22 January 2019

RE: Pronto Bins, Wetherill Park – Response to Additional Information Request for Development Application No. 428.1/2018

Figure 1: Project location

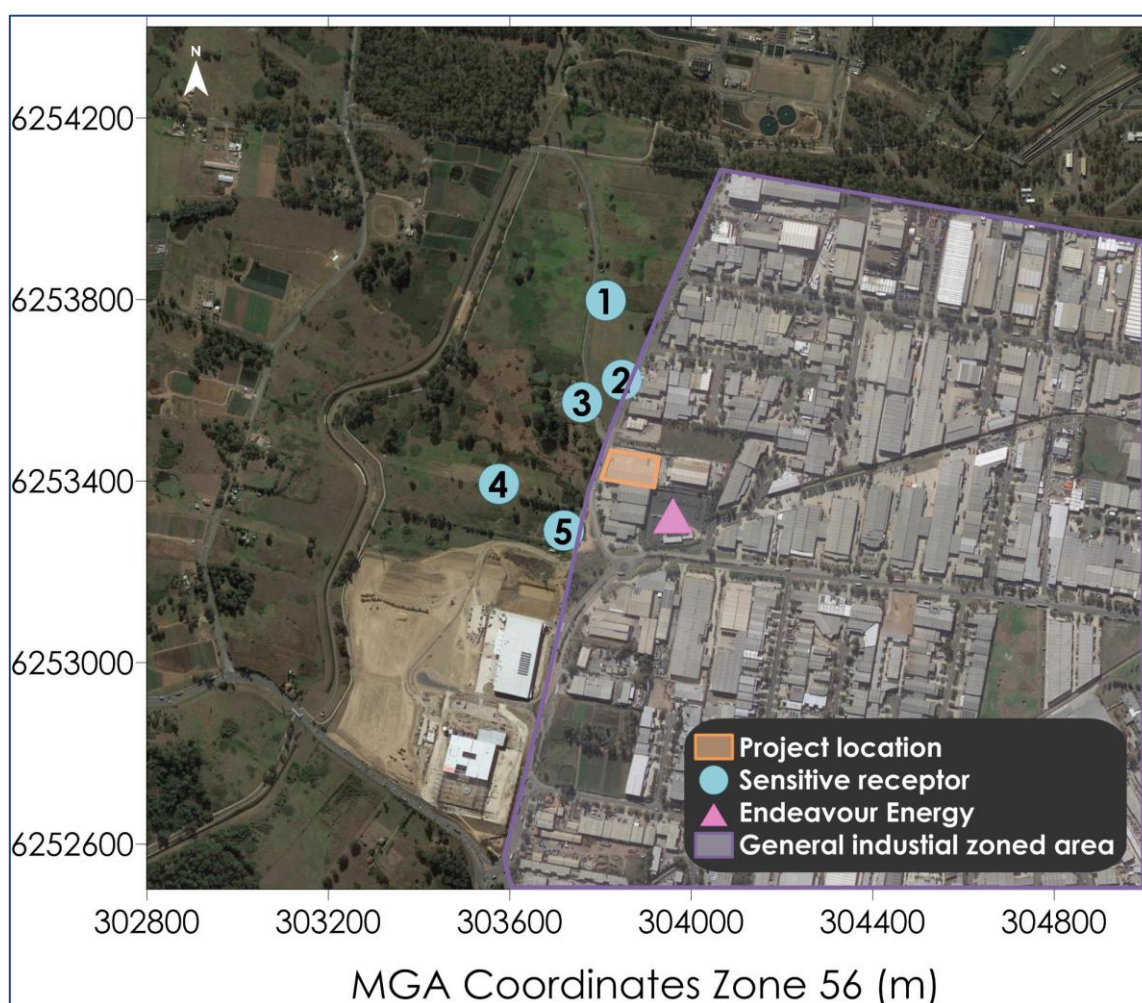
- *Section 2.1 'Project setting' describes the site as being 'situated in a general industrial area with the land use in the surrounding area characterised as a mix of commercial/industrial, rural, residential and recreational parklands' without specifically mentioning Endeavour Energy's West Wetherill Park Transmission Substation.*

The Endeavour Energy West Wetherill Park Transmission Substation is located within an area zoned as "general industrial" as per the Fairfield City Council Local Environment Plan 2013 (**Fairfield City Council, 2018**).

Figure 1 presents the Project location relative to the Endeavour Energy West Wetherill Park Transmission Substation (Endeavour Energy).

To assess the potential for air quality impacts associated with Project, the Endeavour Energy site was input as a discrete receptor into the air dispersion model for the Project. The predicted air quality levels were assessed in a similar fashion to the other identified sensitive receptors in the Air Quality Impact Assessment (**Todoroski Air Sciences, 2018**).
